CROSSPOINTE MEADOWS ACCESSORY BUILDING JSP 19-36

Approval of Preliminary Site Plan and a Section 9 Façade waiver

PLANNING REVIEW

JSP19-36

2 SOUTH ELEVATION
AS1 SCALE: 1/4" = 1'-0"

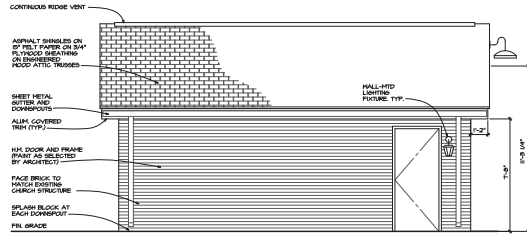
5. Facade requirements for Accessory building in excess of 200 sf Sec. 4.19.1.L: *Materials and architecture shall be compatible with the principal structure, shall have a minimum roof pitch of 3/12 and overhangs of no less than six (6) inches.* **It requires a section 9 waiver as noted in Façade review letter.**

South	North	East	West	Façade Ordinance Section 5.15 Maximum
Brick	23%	70%	52%	50%	100% (30% Minimum)
EIFS	44%	22%	0%	0%	25%
Asphalt Shingles	0%	0%	43%	44%	50%
Trim	33%	8%	5%	6%	15%

As shown above the percentage of Brick is below the minimum amount required by the Ordinance and the percentages of EIFS and Trim are above the maximum amount allowed by the Ordinance on the south façade. These deviations are the result of the large area of overhead door which is not regulated by the Ordinance. Therefore, it is our recommendation that the overall design is consistent with the intent and purpose of the Ordinance and that a Section 9 Waiver be granted for the aforementioned deviations.

- a. To allow the underage of brick on south façade (30% minimum required, 23% proposed) and overage of EIFS on the south façade (25% maximum allowed, 44% proposed) and Trim on the south façade (15% maximum allowed, 33% proposed), because the deviations are a result of the large overhead door which is not regulated by the Ordinance and the plan is consistent with the intent and purpose of the Façade Ordinance, which is hereby granted;
- b. A waiver to allow a painted island in lieu of a raised end island near the entrance to the storage shed, because the drive is only used for dumpster pick up and lawn maintenance vehicles, which is hereby granted;
- c. The findings of compliance with Ordinance standards in the staff review letter and the conditions and the items listed in that letter being addressed.

1 FLOOR PLAN AND LANDSCAPE PLAN
AS1 SCALE: 1/4" = 1'-0"

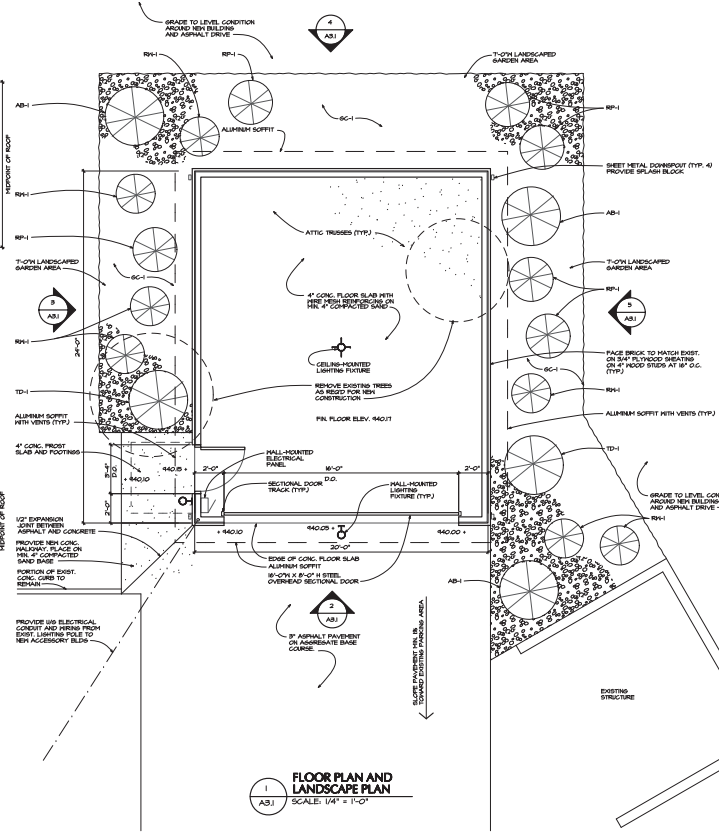
Existing Trees (Sec 37 Woodland Protection, Preliminary Site Plan checklist #17 and LDM 2.3 (2))
Two existing trees to be removed are shown on the landscape plan.

1. Based on the building perimeter, 496 SF of landscape area is required and 565 SF is provided.
2. Please either add additional plantings or spread the proposed plantings around to also cover the rear (north) side of the building (i.e. just mulch does not count as landscaping).

1. Provided
2. 1 of 4 species used (*Thuja occidentalis*) is native to Michigan. Please either add species or change one or more of the proposed species such that at least 50% are native to Michigan.

1. Provided
2. Please add standard costs for the plants and mulch used in the project and a total cost of the landscape materials (\$400/deciduous canopy tree, \$250/ornamental tree, \$50/shrub and \$35/cyd for mulch).

PARTIAL SITE PLAN
 SCALE: 1" = 80'

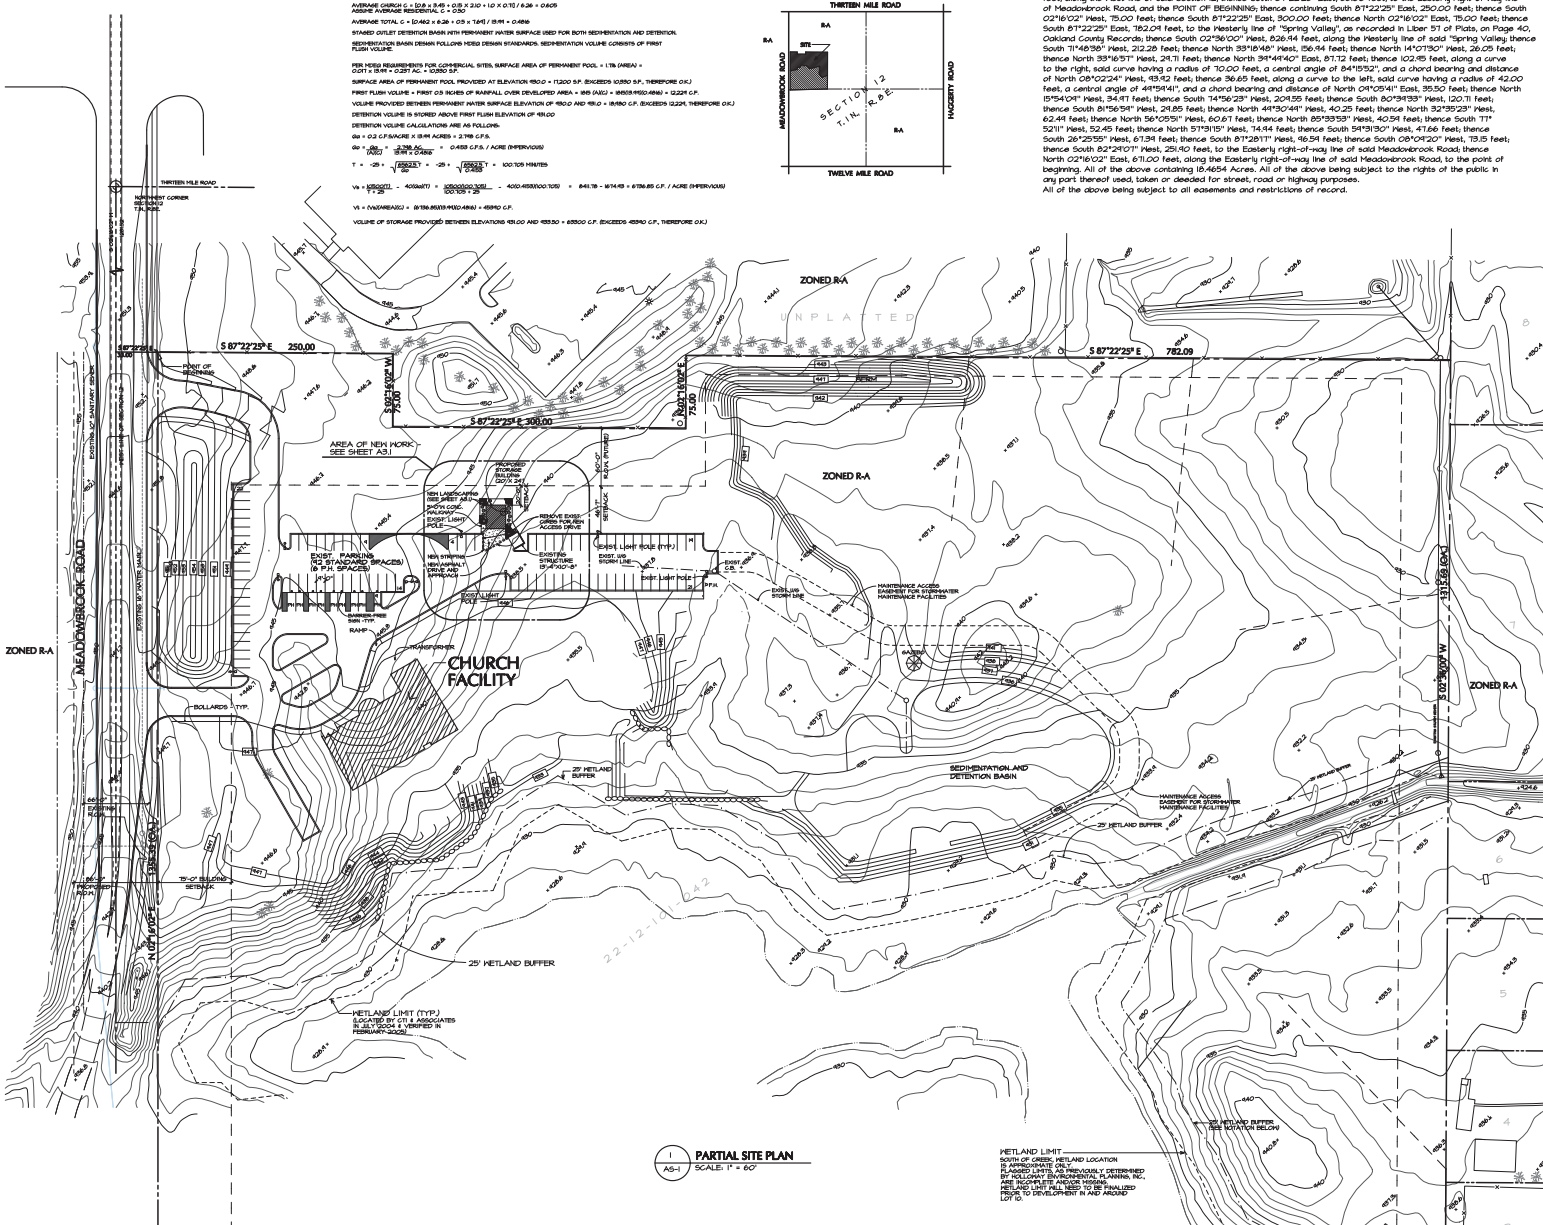
4. Either an end island or a striped area will be required between the proposed structure's drive approach and the existing parking spaces adjacent to it, to the immediate west. End island shall be designed in accordance with Section 5.3 of the City of Novi Zoning Ordinance, including 10 foot minimum interior width, 200 square-foot minimum interior area, and at least one tree. A striped area in lieu of the end island would require a waiver from the Planning Commission.
5. Revise the pavement cross section shown on sheet A3.1 to comply with the "Minimum Bituminous Parking Section" (Detail 7C) on sheet 2 of the City of Novi Standard Paving Details.
6. The plan appears to show obsolete contours from the original development of the property. Remove said contours for clarity.

1. No changes to the parking lot are proposed so no new parking lot landscaping is required.
2. **The perimeter trees that are being removed for this project must be replaced along the parking lot perimeter.**

1. Section 9 waiver for the building materials on the façade.
2. Planning Commission waiver to provide painted island striping at the existing parking area adjacent to the new access drive to the Accessory building.
